# Access Compliance Report

## Public Rights-of-Way

| Intersection ID: 51704 | Main Street: IKEA_BV | Cross Street: BROOKSIDE_LN | Location: NW           |
| ADA ID: C30867EA8A6D   | Ramp Type: Perp      | Initial Pass/Fail: Fail    | Overall Compliance: No |

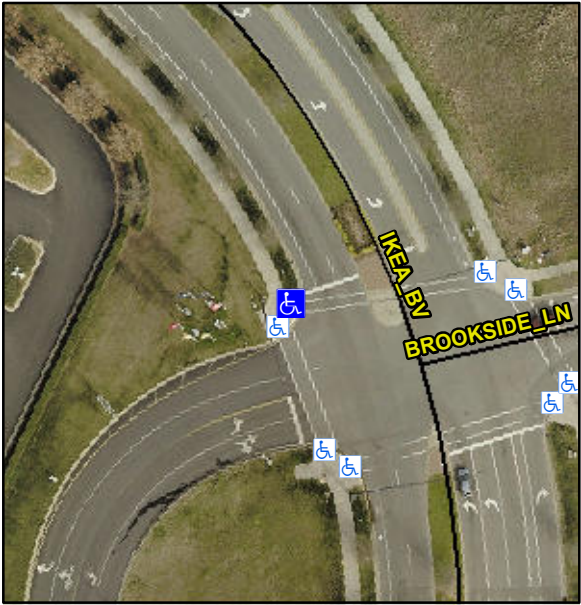
| Codes/Mitigation Info/Possible Solution   |  |  | Field Measurements/Component Compliance |                       |             |                          |
|---|--|--|---|-----------------------|-------------|--------------------------|
|   |  |  | No                                      | Ramp Width (in)       | 46.5        | Yes                      |
| <p>Surveyor Notes:</p> <p><b>N/A</b></p> <p>PROW/ADA:</p> <p><b>Not Found, R304.5.1</b></p> |  |  | N/A                                     | Flare Type RT         | N/A         | N/A                      |

| Codes/Mitigation Info/Possible Solution   |  |  | Field Measurements/Component Compliance |                       |             |                          |
|---|--|--|---|-----------------------|-------------|--------------------------|
|   | <b>Remove &amp; Replace Entire Ramp.</b> |  | <b>Description</b>                      |                       |             | <b>Description</b>       |
